ADDENDUM NO. 5

HANOVER CENTRAL HIGH SCHOOL ADDITIONS AND RENOVATIONS Cedar Lake, IN 46303

ADDENDUM FIVE

Addendum Five (AD.05) to the drawings and specifications prepared by Gibraltar Design and The Skillman Corporation for **Hanover High School Addition and Renovations** for Hanover Community School Corporation, Cedar Lake, Indiana.

B	S-204
---	-------

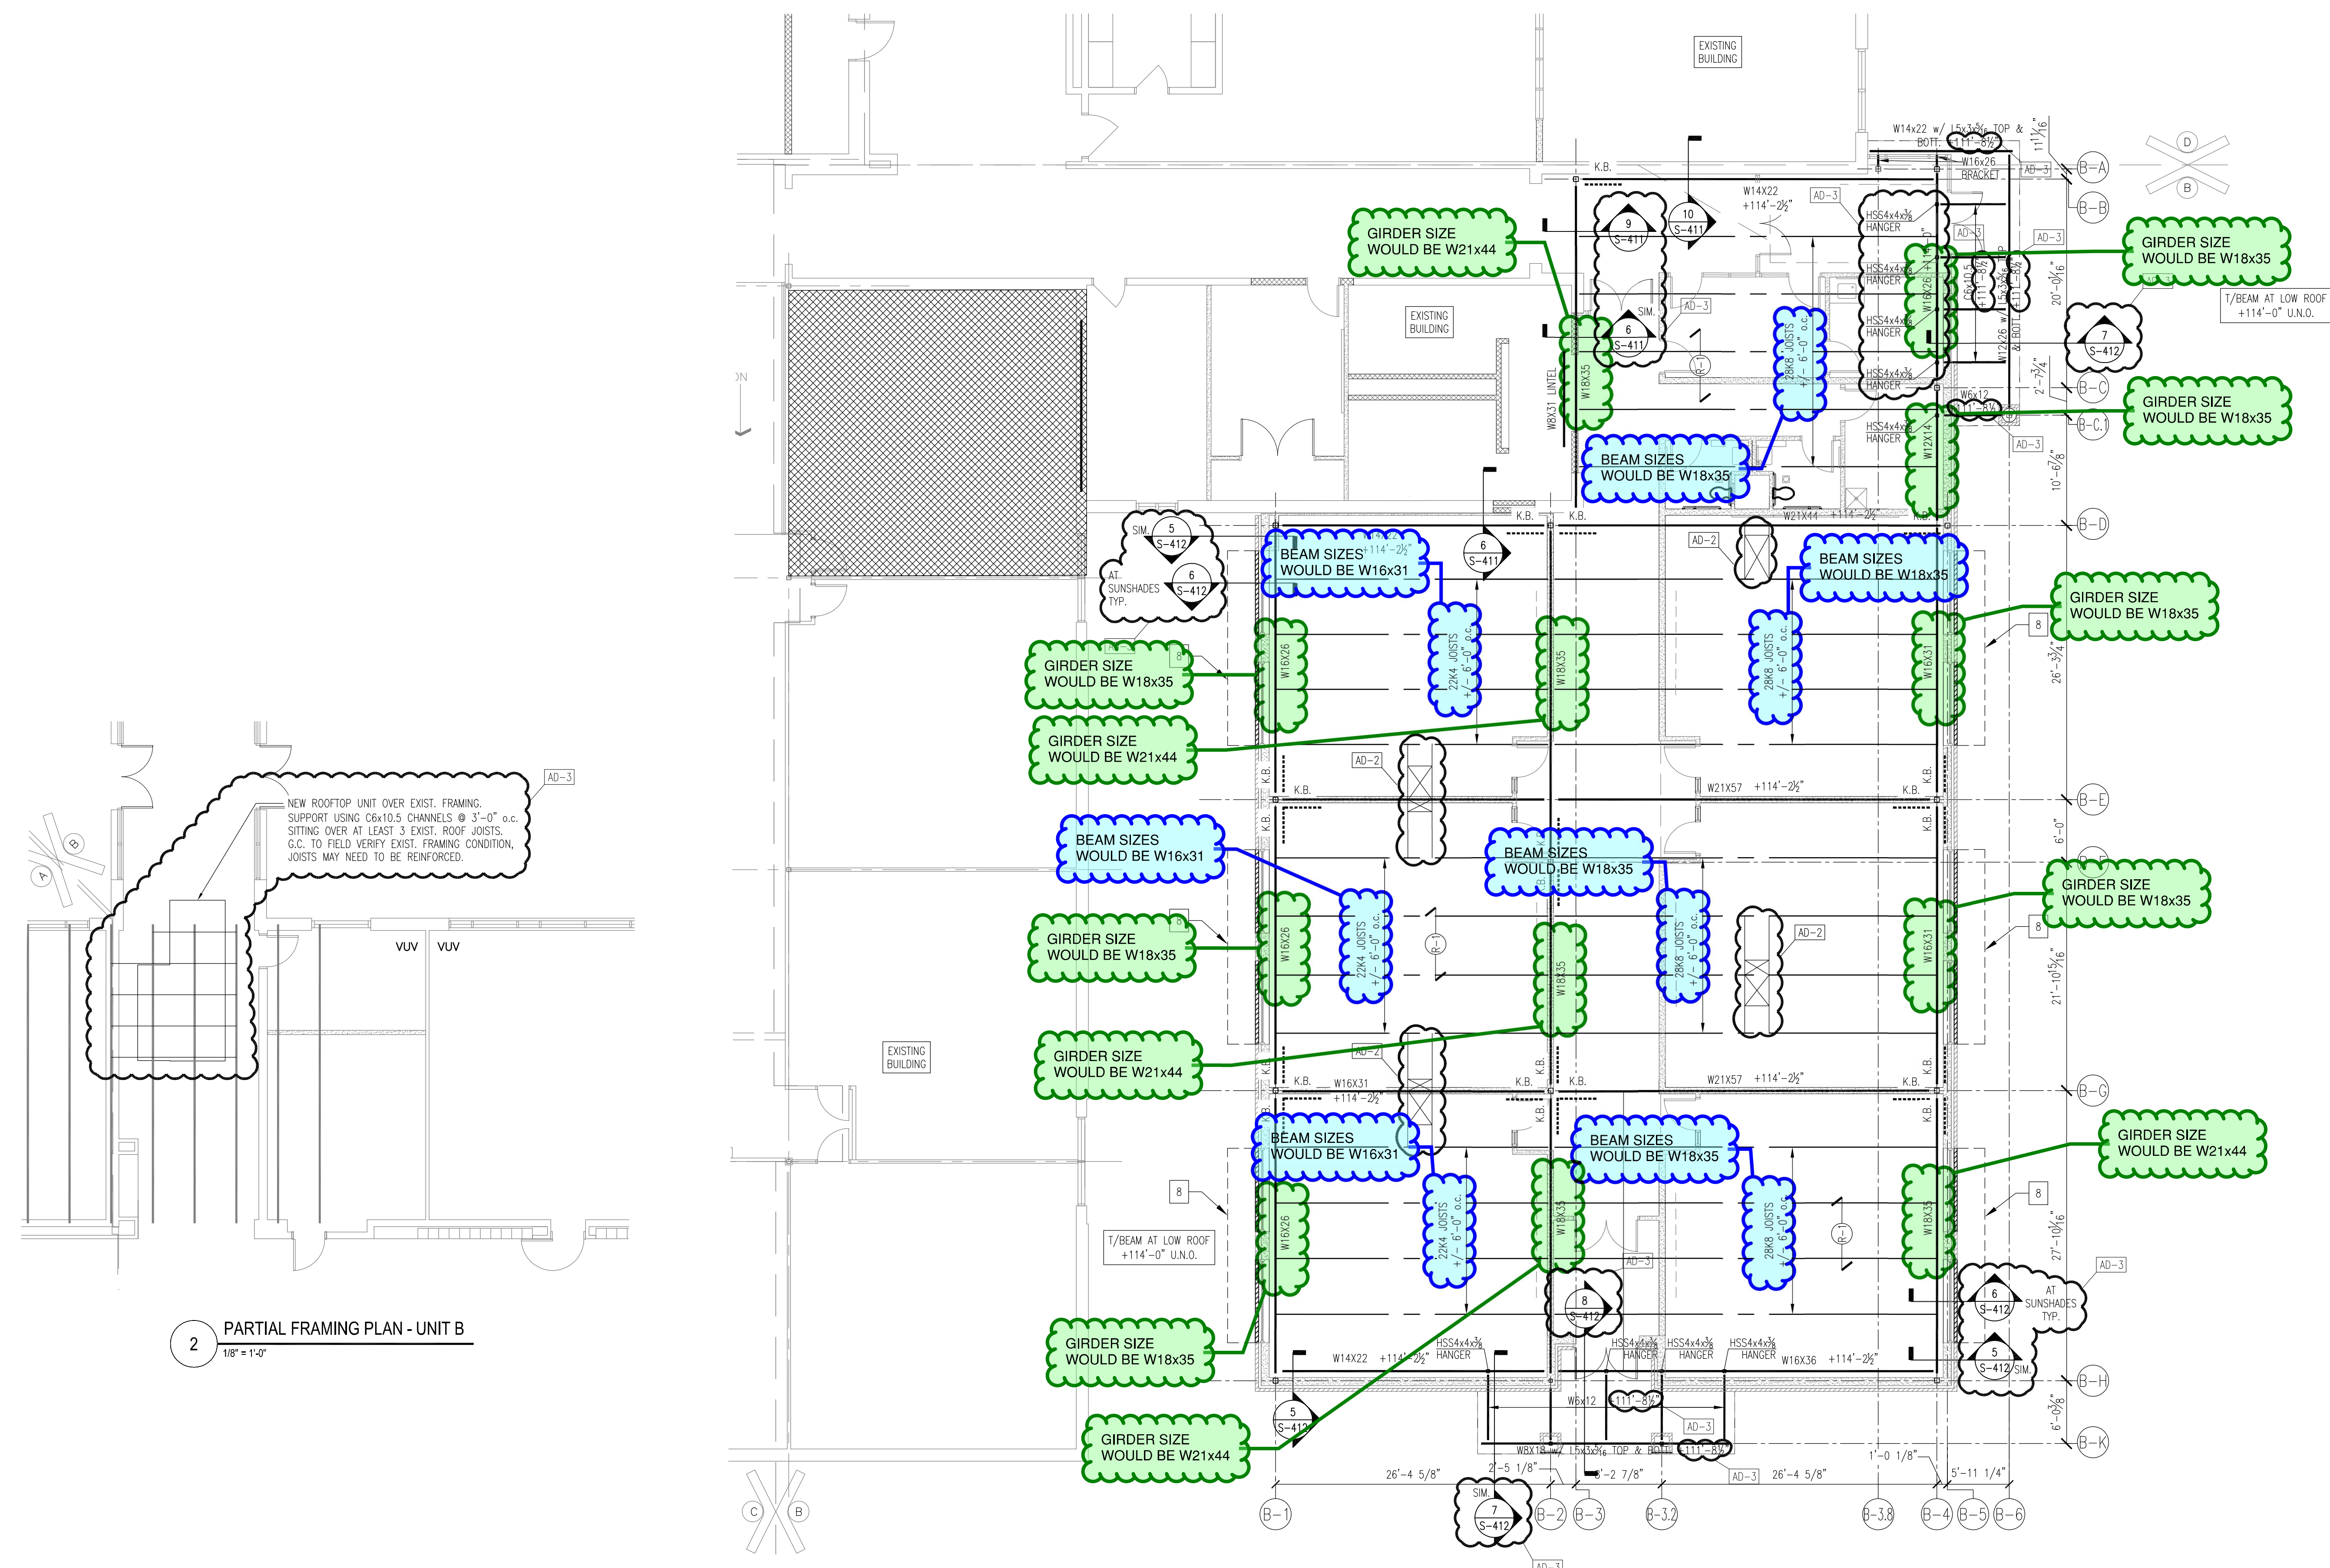
ALTERNATE NO. 9: Reference Alternate Sheets S-203 and S-204 for revisions utilizing structural steel beams in lieu of steel joists. Contractors are to use drawings/sheets as guide for size and number of revisions required and include in their pricing all necessary connections and erection considerations for a complete installation. Base Bid is to be per current construction documents (joist design).

- A. Refer to new full-size drawing, included in this Addendum.

A-105

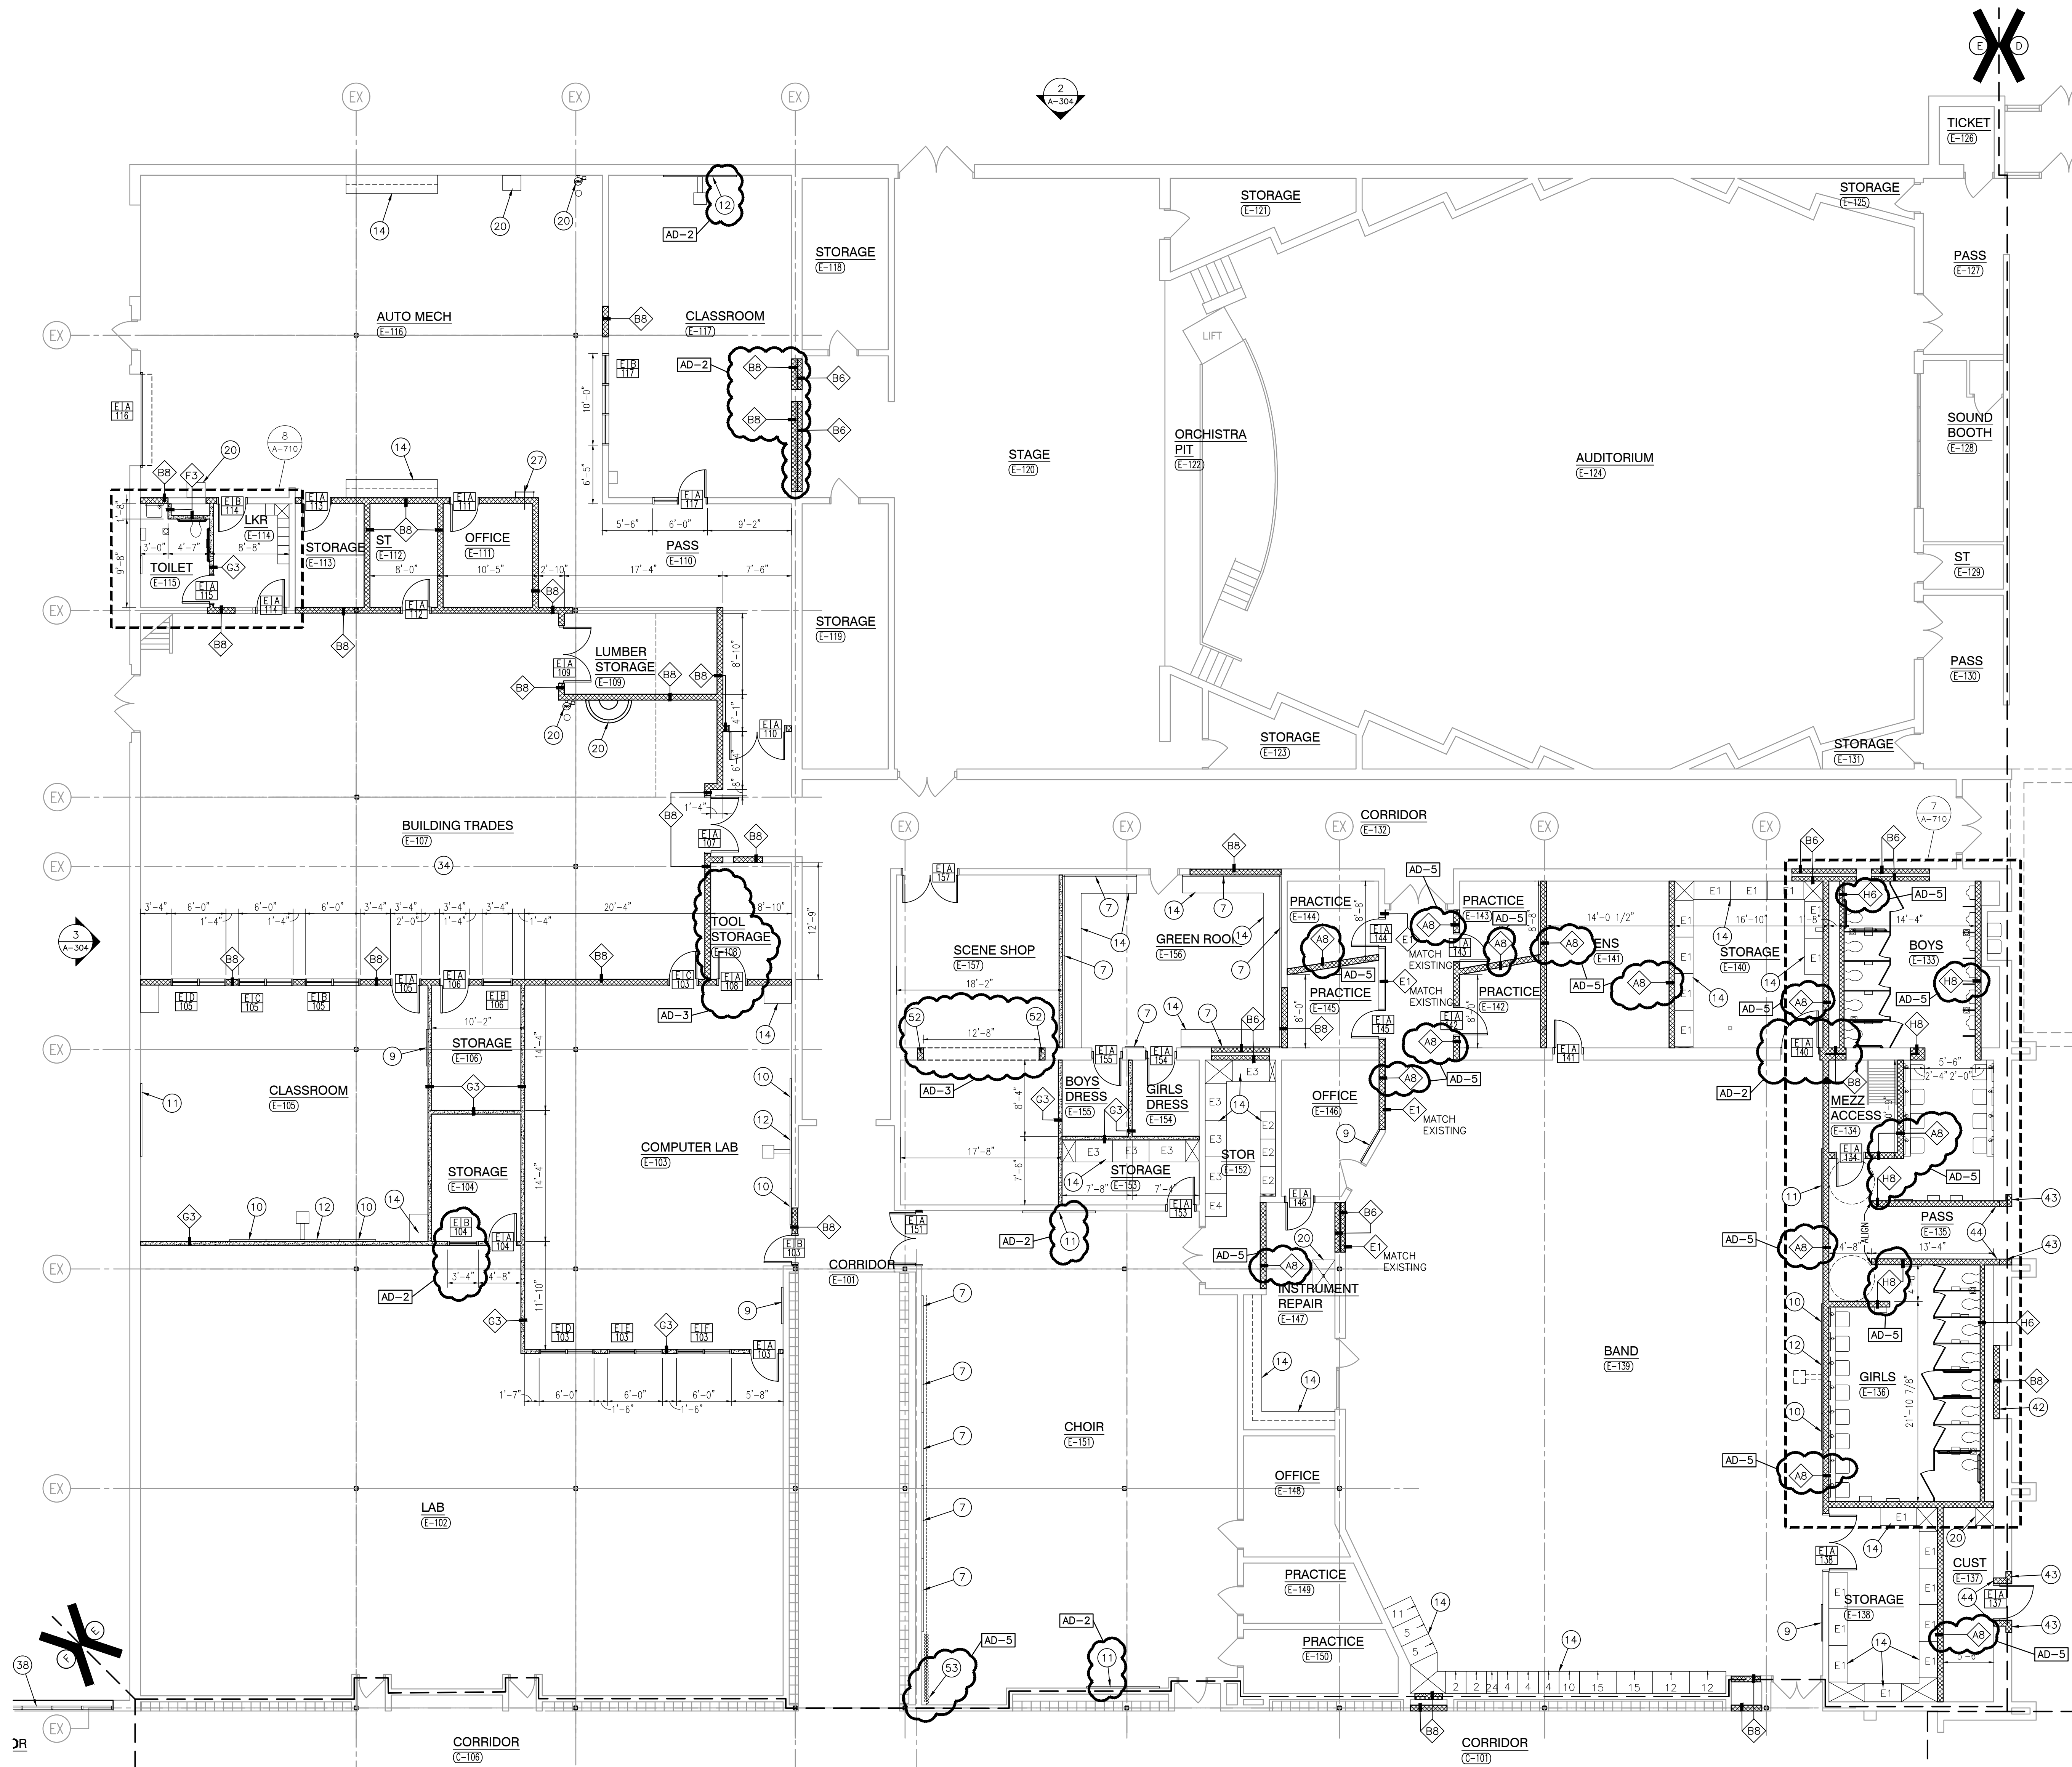
- A. Refer to revised full-size drawing, included in this Addendum, for the following revisions:
 - 1. Plan Notes: Add Note 53.
 - 2. Change Note 16 to Note 53 in Choir E-151.
 - 3. Revise wall type tags

GIBRALTAR DESIGN SHEET
F MP106

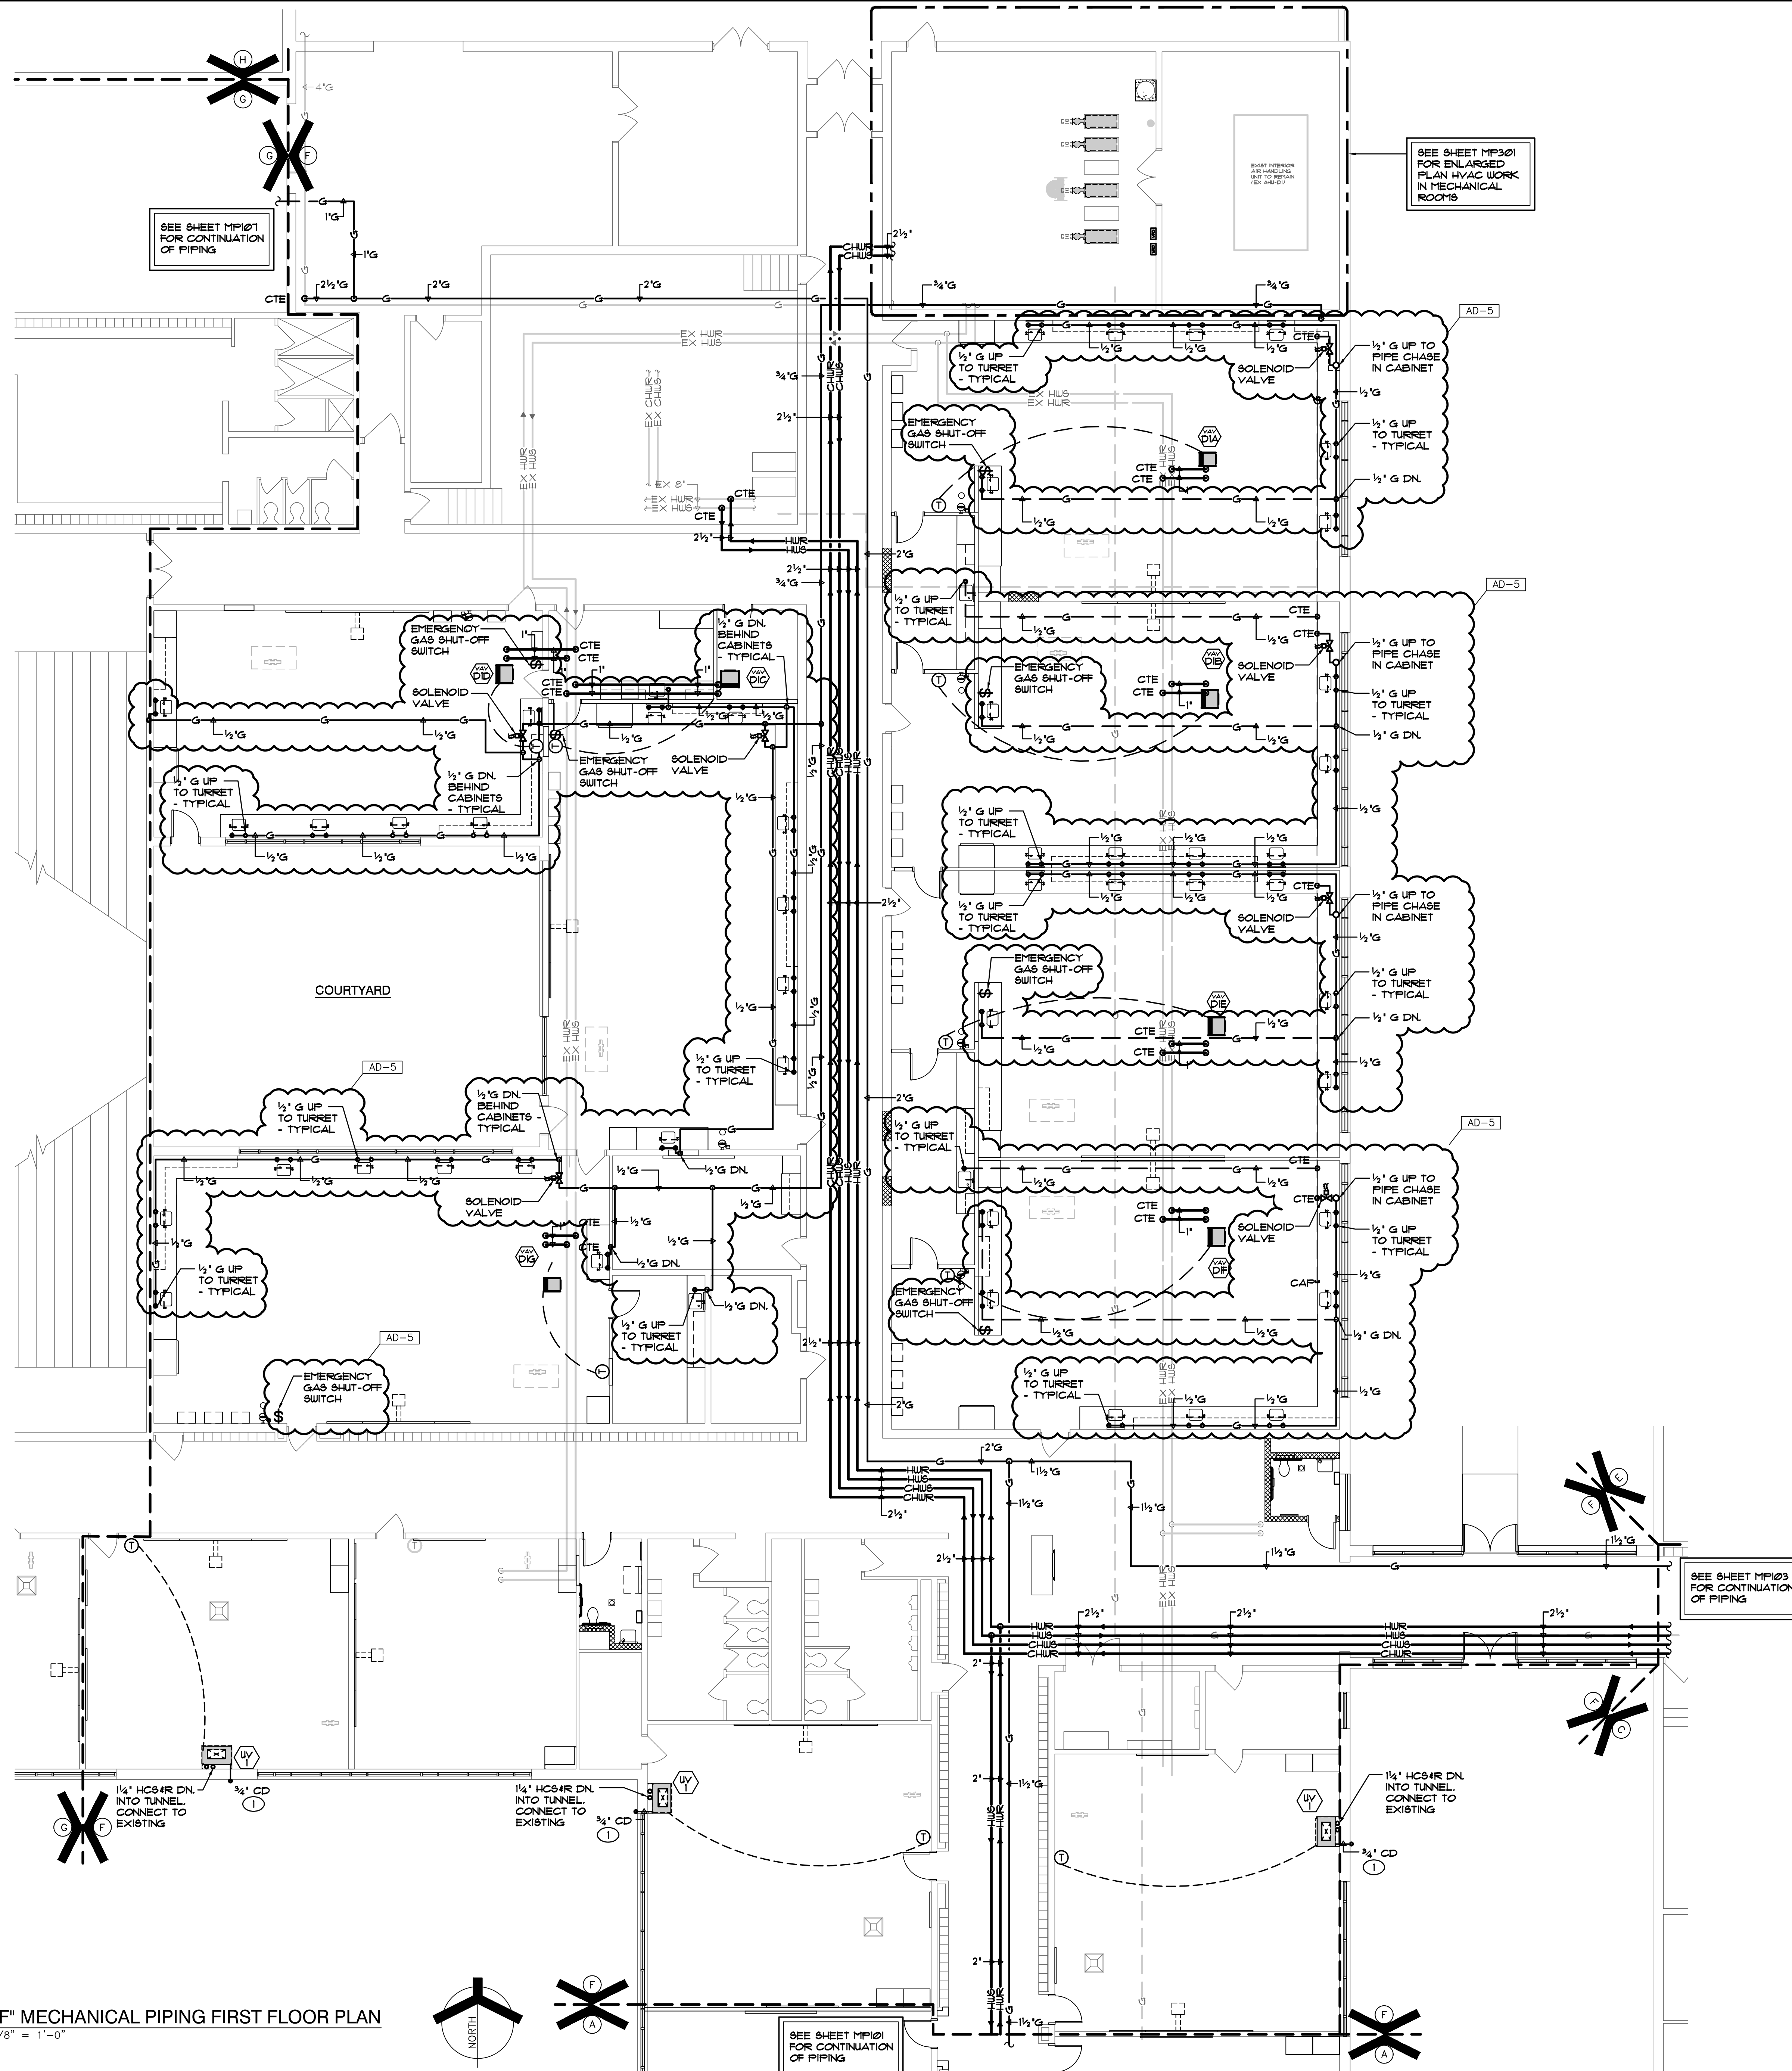
- A. Refer to revised full-size drawing, included in this Addendum, for the following revisions:
 - 1. Rerouted gas piping going to gas turrets in Science rooms.
 - 2. Added solenoid valves and emergency shut-offs in Science rooms.
